**Brooklyn Inland Wetlands Commission**  
**Regular Meeting Agenda**  
**Tuesday, June 14, 2022**  
**Zoom and In-Person Meeting**  
**Clifford B. Green Memorial Center**  
**69 South Main Street**  
**6:00 p.m.**

1. **041222B – Paradise Drive - Map 14 Lot 6** – John E. Sweat, Jr. Improvements to an existing gravel driveway, construction of a bridge spanning Tatnic Brook, construction of a new single-family dwelling.
2. **041222E – 14 Hugh Drive - Map 36 Lot 31** – Devon Gibson. Failed septic system; new system to be constructed.

## ENGINEERING PLAN AND DOCUMENTS REVIEW PERTAINING TO A RESIDENTIAL SITE DEVELOPMENT PLAN PARADISE DRIVE BROOKLYN, CT (May 2, 2022)

The comments contained herein pertain to my review of plans (3 sheets) entitled "Improvement Location & Topographic Survey, Residential Site Development Plan, Prepared for John E. Sweat, Jr., Paradise Drive, Brooklyn, Connecticut" prepared by Boundaries, LLC, dated March 2022 with Revision Date of April 25, 2022, and other supporting documents.

1  
3

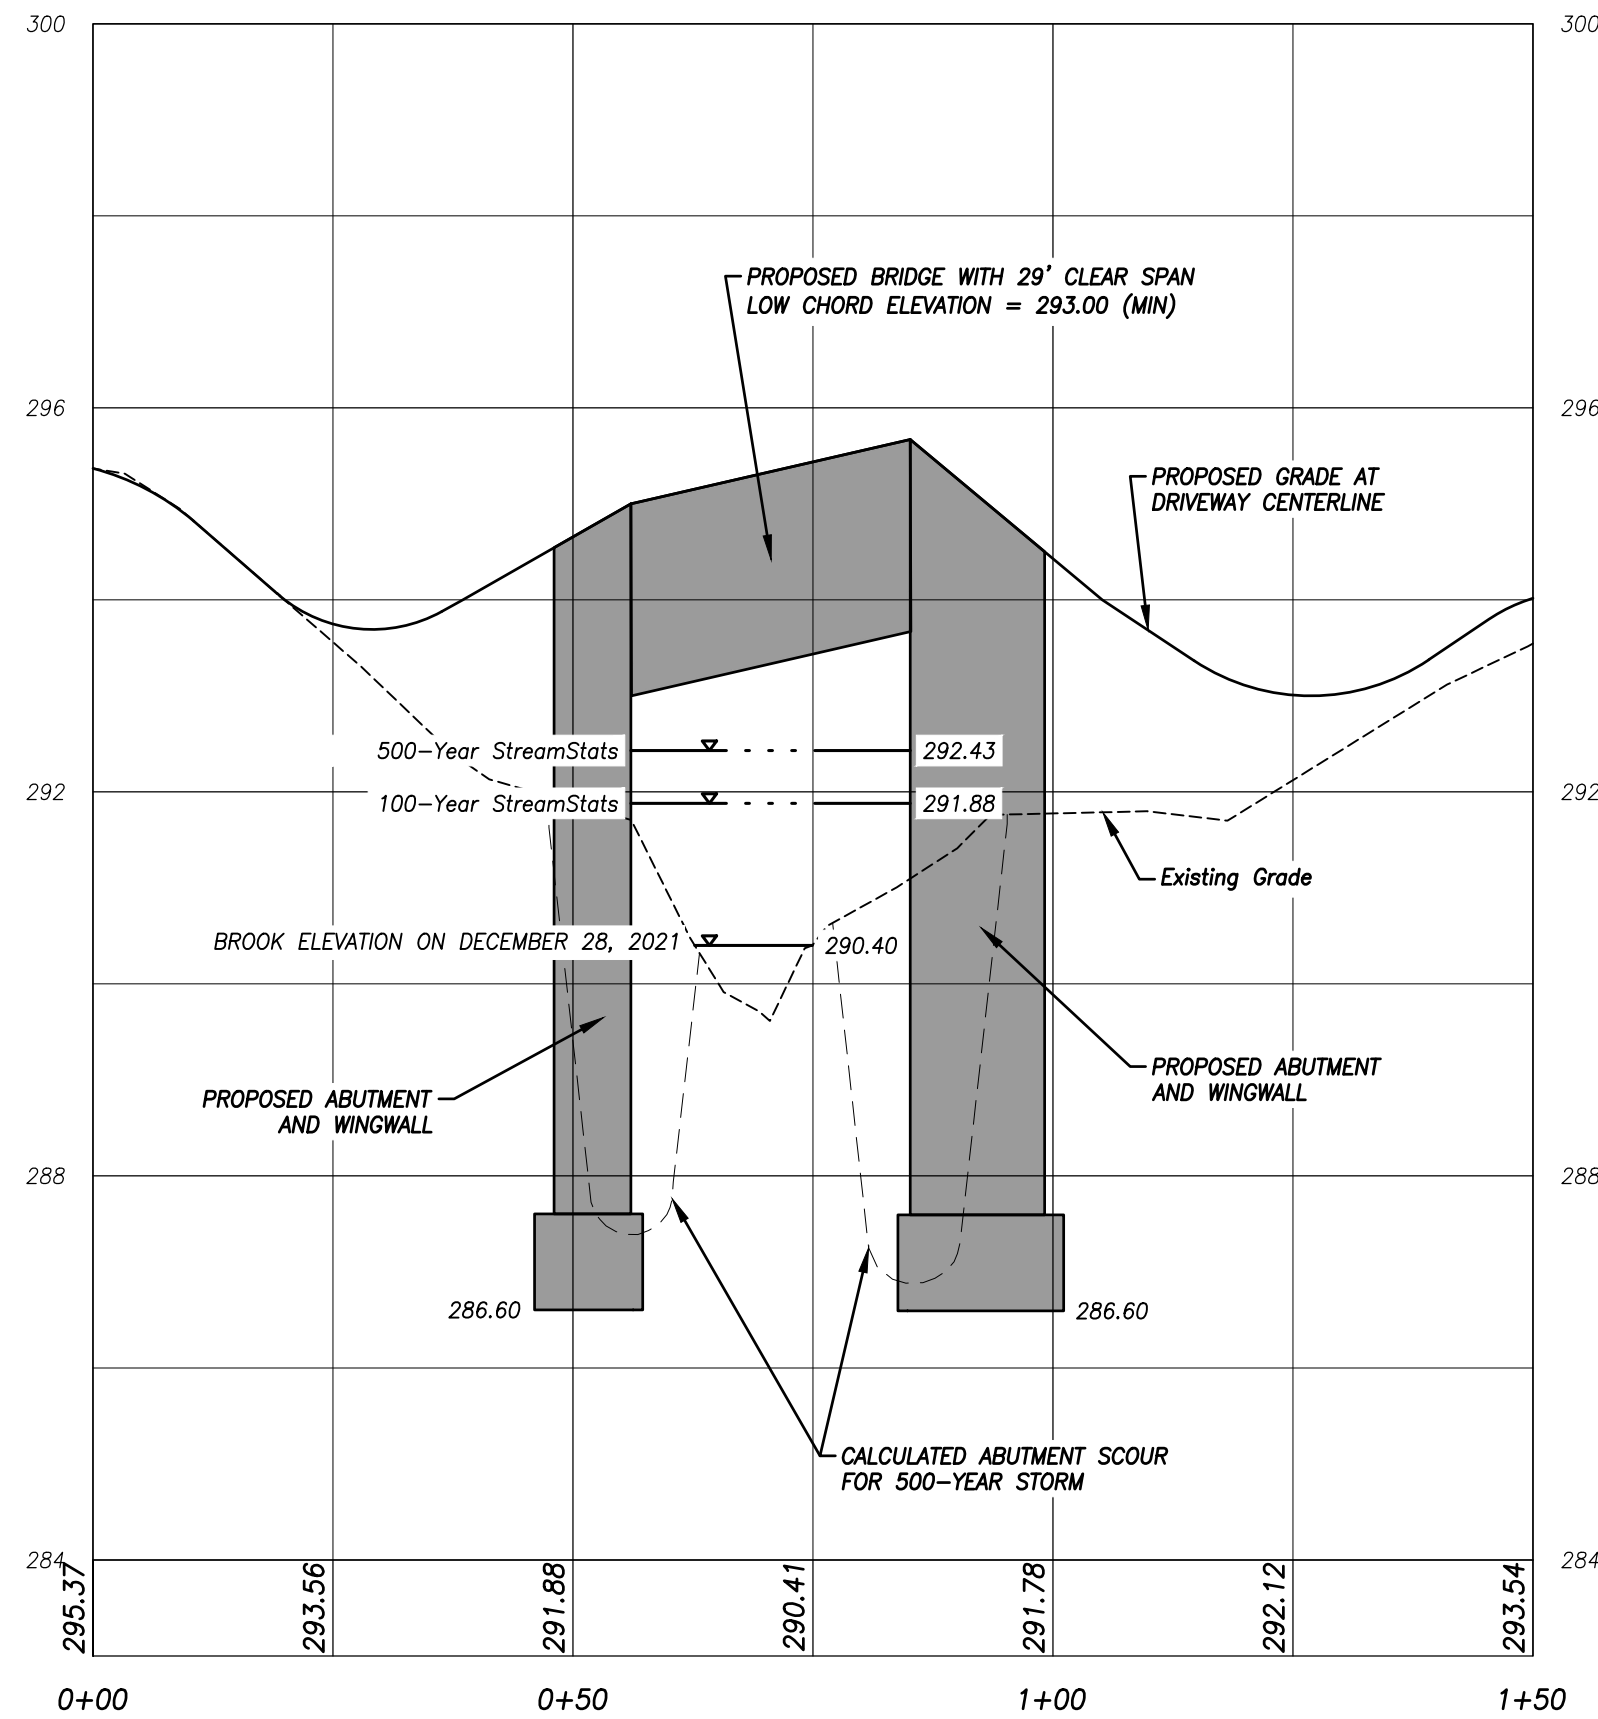
1. The revised plan now includes the current (in force) FEMA FIRM 100-year flood zone (FIRM Map Panel No. 090164 0007 A dated January 3, 1985). However, the 100-year floodplain shown on the plan was, and remains, designated as that of FEMA FIRM Map Panel No. 09015C0238F, which was not in effect at the time the wetland application was submitted, nor is it in effect at the time of this review. This needs to be addressed by Boundaries in that it should be removed from the plan to avoid confusion because it does not exist for the purposes of the wetlands application under review. Incidentally, when the online FEMA Flood Map Service Center is queried, only the 1985 map is displayed.

2. The existing 1985 Flood Insurance Rate Map (FIRM) floodplain limits depicted on the plan clearly demonstrate that the proposed house, drinking water well, septic system and practically the entire driveway are within the 100-year flood zone (floodplain) and, therefore, located wholly within the regulated wetland.

**Comment 2.** You have depicted the as-yet-unadopted Flood Zone, not the one that is in effect right now. We are required to use the one that is in effect. Our zoning map will be changed after the FEMA map has officially been changed. If you have an approved letter of map amendment, would you please share that with me?

**Comment 1.** Provide a best management practice to collect runoff from the driveway before it drains to the stream.

**Response 2.** The site plan has been revised to incorporate the flood plain as depicted on the effective Flood Insurance Rate Map from 1985. The flood plain per the effective map encompasses the majority of the property. Based on the location of the 1985 flood plain and the proposed house site, a Letter of Map Amendment will be required prior to applying for zoning or building permits. Please note that the Letter of Map Amendment for 25 Paradise Drive, upstream of the proposed project, sets the elevation of the Flood Plain at 294.5 (NGVD29)/293.7 (NAVD88). The proposed basement elevation is elevation 298.0,

well above the flood plain elevation upstream of the proposed house site. Additional information regarding compensatory storage within the flood plain has also been added to the revised site plans.

**Response 1.** Four “rain gardens” have been added to the site plans adjacent to the bridge abutments to collect runoff from the proposed driveway surface before it can enter the wetlands and water course. The “rain gardens” are 20 feet long by 15 feet wide by 1-foot deep and will be seeded with a conservation/wildlife seed mix and stabilized with a straw blanket. The rain gardens are sized with storage capacity for greater than 1-inch of runoff from the contributing driveway surface areas to provide treatment of runoff before it enters the wetlands and watercourse.

**Profile - Centerline Driveway**

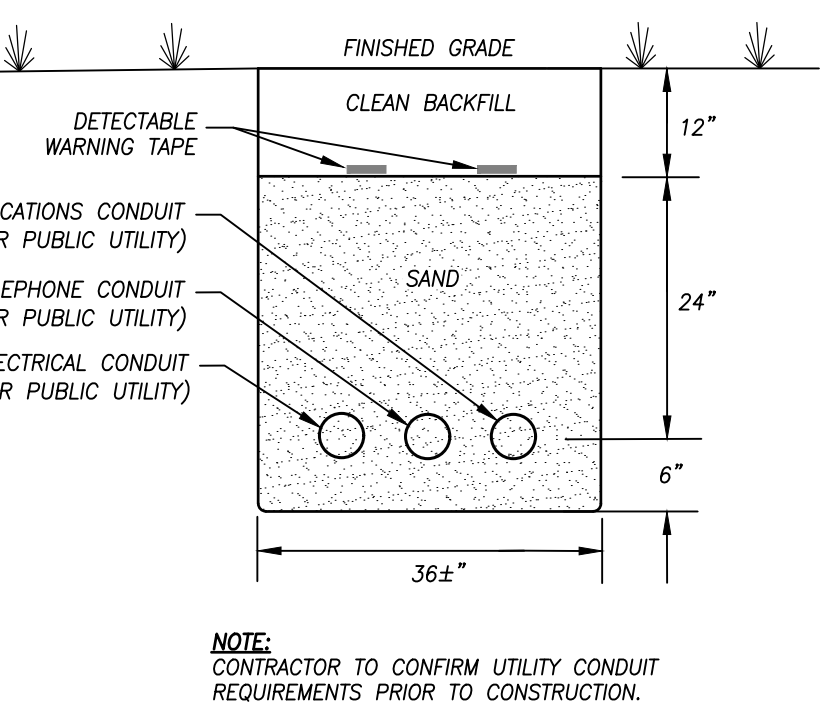
**Comment 2.** Provide structural design plans for the bridge for review.

**Response 2.** The Owner/Applicant has not engaged a structural engineer to design the bridge at this time. The intent is to have the structural design drawings prepared following approval of the concept of a bridge to cross Tatnic Brook and the proposed location in order to avoid taking on the expense of the structural design when approval is not guaranteed.

The site plans include elements that the bridge will be required to meet that provide the basis for the structural design. These are called out on the profile on Sheet 2 and are as follows:
